**Consent Agenda Briefing for PWSRCAC Board of Directors – September 2025**

## Review of Ballast Water Tank 93 Out-of-Service Inspection Report and Tank Repairs

PWSRCAC Contract # 5081.25.01

William Mott P.E.

Figure 3 – Schematic of Tank 93 Perimeter Section

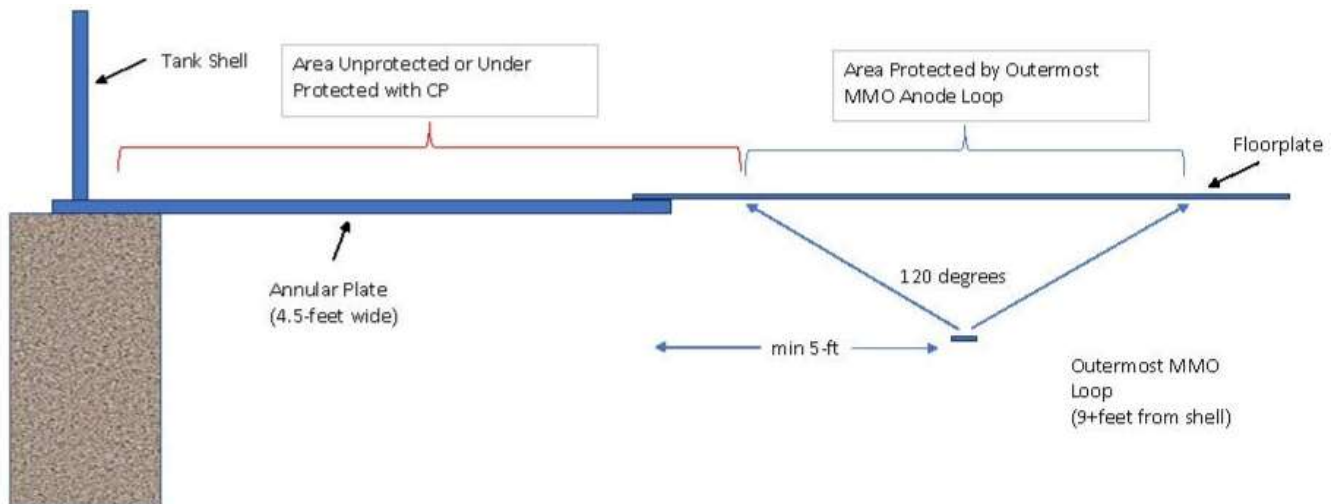
The CP ground bed for the Tank 93 CP system consists of an MMO grid distributed throughout the area beneath the tank floorplate. The CP design includes a separate MMO loop intended to protect the tank's annular plates. According to the design drawings, the outermost anode loop for the existing CP system is more than 9 feet from the tank shell. In this position, the perimeter anode is located beneath the floorplate and not beneath the annular plate (Figure 3).<sup>1</sup>

The location of the perimeter anode is such that it is not physically possible to provide sufficient CP current to the annular plate and first few feet of the perimeter plates.

This anode configuration does not protect the annular plates and perimeter floor plates for the following reasons:

- First, the annular plate and floorplate are welded together and therefore electrically continuous. The MMO loop intended to protect the annular plates and perimeter plates will distribute current primarily via the lowest resistance pathways. In this case, assuming similar backfill resistivity, the current will go to the closest steel, which is the regular floorplate immediately above the anode loop, not the perimeter or annular plate.
- The ratio of floorplate surface area to anode length is significantly larger at the tank perimeter than it is closer to the center. Without the ability to drive the current from the

perimeter anode separately from the remainder to the floorplate, the CP current density to the perimeter floorplate and annular plate will be significantly lower than the rest of the floor.

- Distribution of CP currents is directed by the resistance of the pathway between the structure being protected (the tank floor) and the anode. The longer the distance between the tank floor and the anode, the greater the electrical resistance. The CP current moves along the lowest resistance path and will protect the areas of the floor that are closest to the anode because the electrical resistance is lowest along that path. The general rule of thumb is that the anode can drive current to a pattern within a 120-degree arc from the anode. Beyond that area, the pathway resistance becomes too high for CP current to distribute.

- The MMO loop that is intended to protect the annular plate and perimeter floorplates is tied to a single circuit that cannot be adjusted independently of the floorplate system. Even if the system had the ability to independently power the MMO loop nearest to the annular plate, the resulting CP current would still go predominantly to the floorplate immediately above the perimeter anode loop and will not measurably impact the annular plate or outer perimeter plate surfaces.

- Taku recommends the CP systems for Ballast Water Storage Tank 93 be upgraded in the perimeter areas to protect those areas from corrosion.
- Taku recommends the CP system monitoring tubes be slotted in the perimeter area to allow CP monitoring of that area, to ensure effective corrosion mitigation.

Figure 4 – Predicted Versus Actual Corrosion Depths for Tank 93

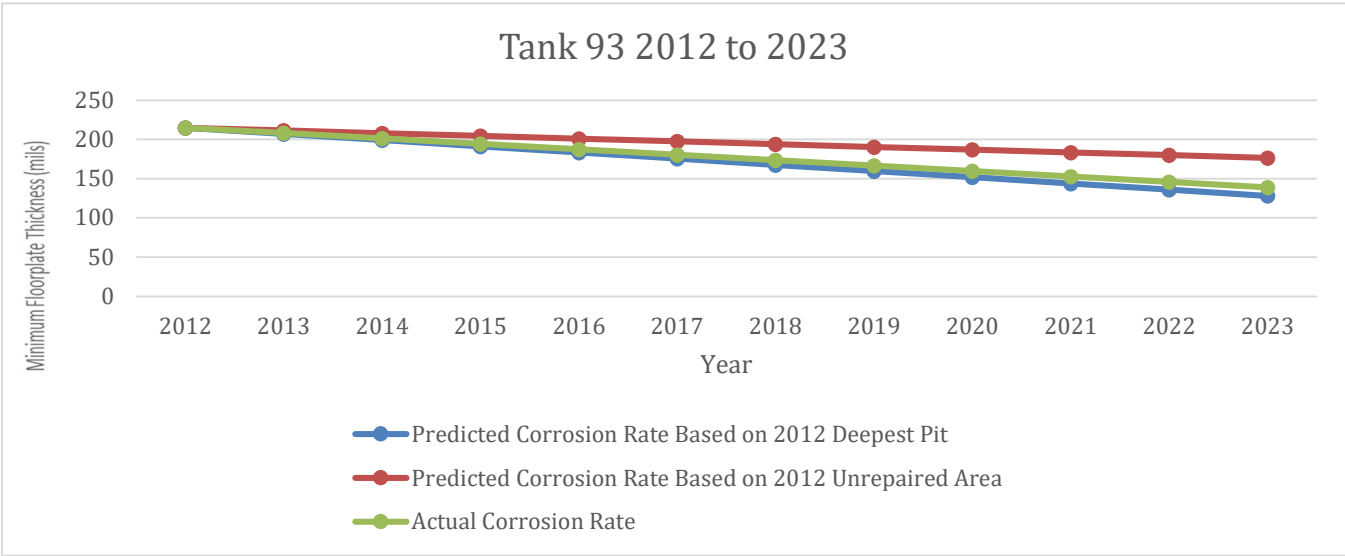
The deepest pit discovered during a VMT tank inspection should be utilized to set the next service interval, regardless of repair thresholds. Revisiting the 2012 inspection and repair results provides another data point supporting this approach. Figure 4 graphically illustrates the predicted and actual corrosion rates for Tank 93 for the 2012-2023 period based on the 2012 inspection and current inspection findings.

The red line in the graph represents the predicted corrosion rate using the deepest unrepaired pit from 2012 (as allowed by API 653). Based on the deepest unrepaired pit after the 2012 inspection (215 mils RFT), the predicted corrosion rate for the Tank 94 floorplate was 3.5 MPY and the predicted deepest pit in 2021 was 180 mils RFT.

The use of the deepest pit from the 2012 inspection (171 mils RFT) to calculate corrosion rate and predict the deepest pit in 2023, resulted in a 2012-2023 predicted corrosion rate of 7.9 MPY and a predicted deepest pit (in 2023) of 128 mils RFT. This is represented by the blue line in Figure 4.

The actual deepest floorplate pit identified in 2023 was 139 mils RFT, representing a corrosion rate of 6.9 MPY. This is represented by the green line in Figure 4.

Using the 2012 deepest pit to define the 2012-2023 corrosion rate, the actual rate of corrosion was over-estimated by 14%. Using the deepest unrepaired pit (from the 2012 inspection) to predict the Tank 93 floorplate corrosion rate between 2012 and 2023, the actual corrosion rate was underestimated by 49%.

We commend that Alyeska is using the deepest overall pit to calculate corrosion rates and service intervals in their tank Engineering Summary Reports. However, they continue to use the deepest unrepaired pit to calculate corrosion rates and service intervals in their API 653 Reports. *This creates unnecessary confusion and risk.* Inspection reporting should be consistent. The API 653 Reports should utilize the more accurate methodology that aligns with the Engineering Summary Reports. This is a simple, inexpensive step that can alleviate risk and confusion.
